weekly notice

Monday, 14 August 2017
Sunday, 20 August 2017

*GENERAL MANAGER SAFETY AND STANDARDS
SYDNEY TRAINS*

Signalling Arrangement VER 22062017

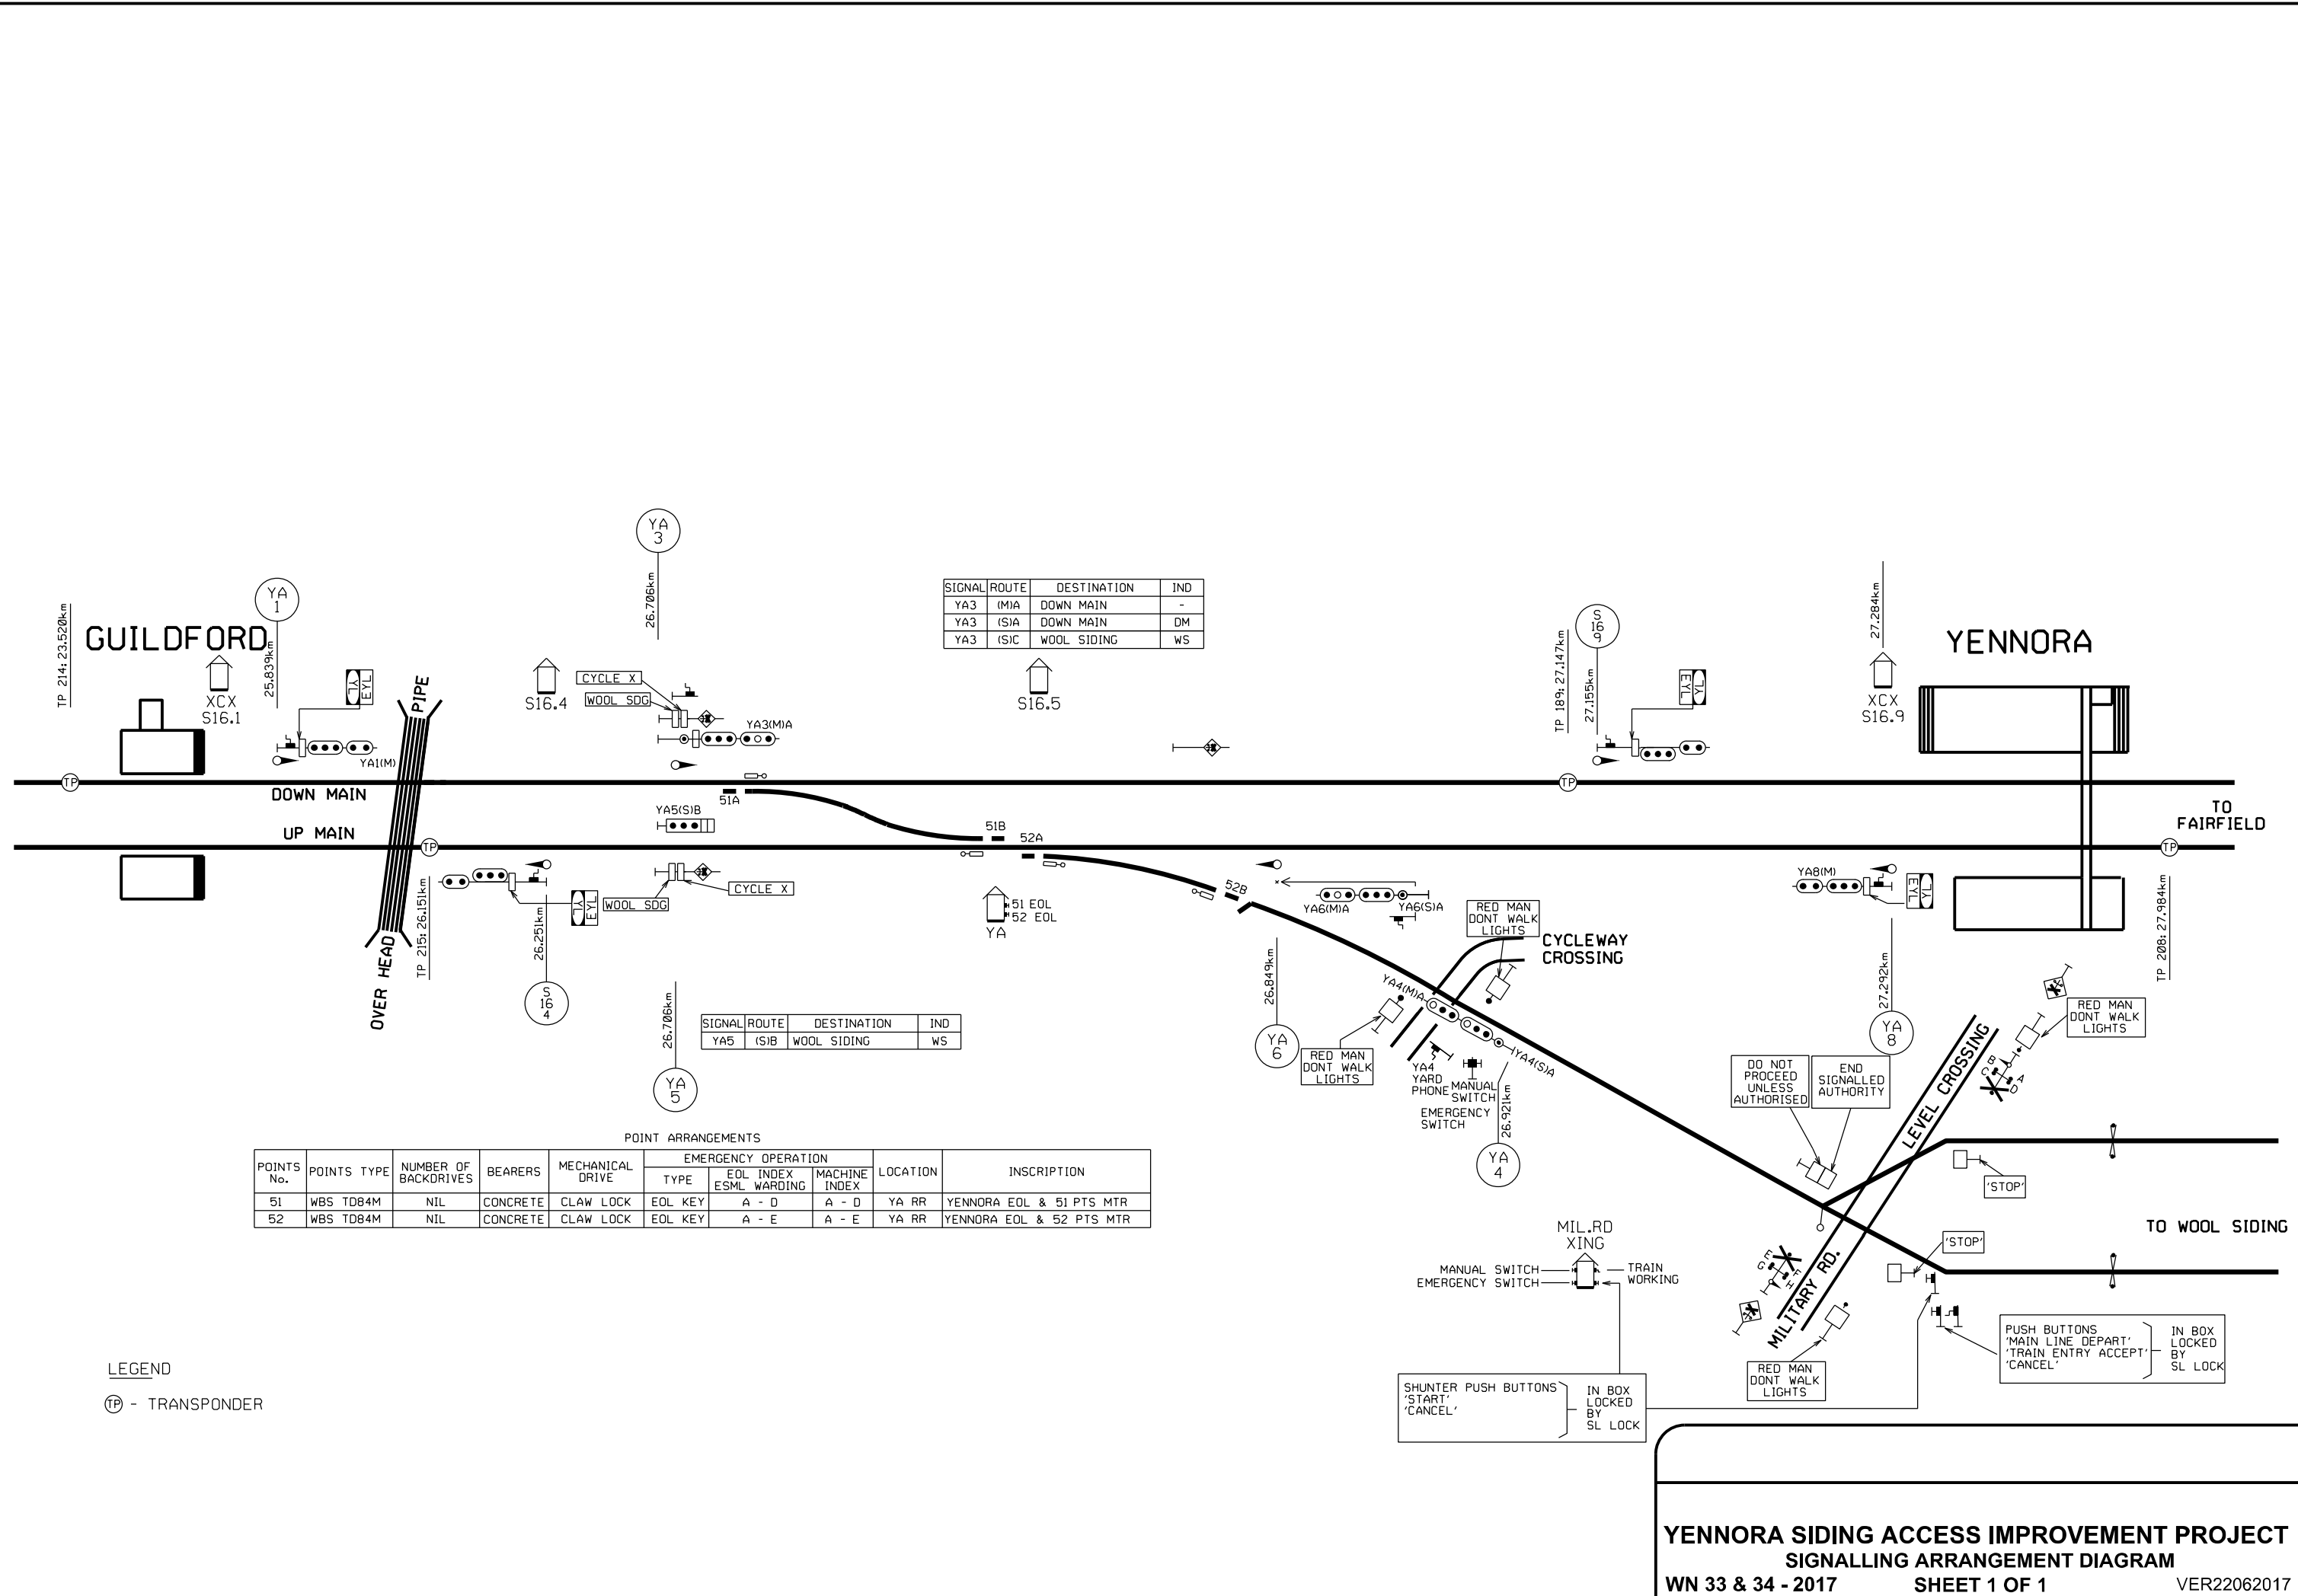
YENNORA SIDING ACCESS IMPROVEMENT – FINAL COMMISSIONING

- YA1, YA3, YA4, YA5, YA6, YA8 – signals.
- 51A/B and 52A/B - points.

YA3 & YA5 signal routes into the siding will operate as a dual control signal. The yard shunter will provide the Sydney Trains Signaller on Sefton ATRICS panel control of these signals by accepting entry into the yard through the local control panel. The Sydney Trains signaller will receive a yellow indicator on the Sefton ATRICS panel to advise when control has been accepted by the Yard Shunter.

SIGNAL / ROUTE	KM	STATUS	DESCRIPTION	ROUTE INDICATOR	REMARKS
YA3	26.706	Existing	Down Home, Down Main	(S)A - DM (S)C - WS	Existing auto onverted to controlled signal. New Shunt stencil indicator added to indicate (S)A & S(C) Routes leading to Down Main and Wool Sidings. (S)C route into the sidings not to clear without 'Train Accept' release given by the Siding Operator. 'A; light removed New level crossing and cycle path advanced warning boards provided.
YA4	26.921	Existing	Up Home, Up Main		Existing signal removed and relocated with new LED type signal on the yard side of the cycle path crossing. New shunt aspect provided.

SIGNAL / ROUTE	KM	STATUS	DESCRIPTION	ROUTE INDICATOR	REMARKS
YA5	26.706	New	Up Shunt Up Main	WS	New shunt signal with route indicator. Signal route only to be used under possession and requires a push pull operation between the train drivers. Route into the sidings not to clear without 'Train Accept' release given by the Siding Operator. New level crossing and cycle path advanced warning boards provided on the right hand side of the track.
YA6	26.849	Existing	Up Home Up Main		'A' light removed New shunt aspect provided.
YA8	27.292	Existing	Up Accept Up Main		Existing auto signal replaced with new controlled signal. New YL/EYL boards provided.
S16.4	26.251	Existing	Up Auto Up Main		New YL/EYL boards provided
S16.9	27.155	Existing	Down Auto Down Main		New YL/EYL boards provided

Existing transponder TP 209 at 26.972 will be removed and Liverpool train radio signaller control will be extended to new transponder TP 214 at 23.520. Granville existing radio control section will be altered to control from the new transponder TP 214 at 23.520 toward Sydney side.

Existing transponder TP 208 at 27.984 will be re-configured and new transponder TP 215 will be provided at 26.151.
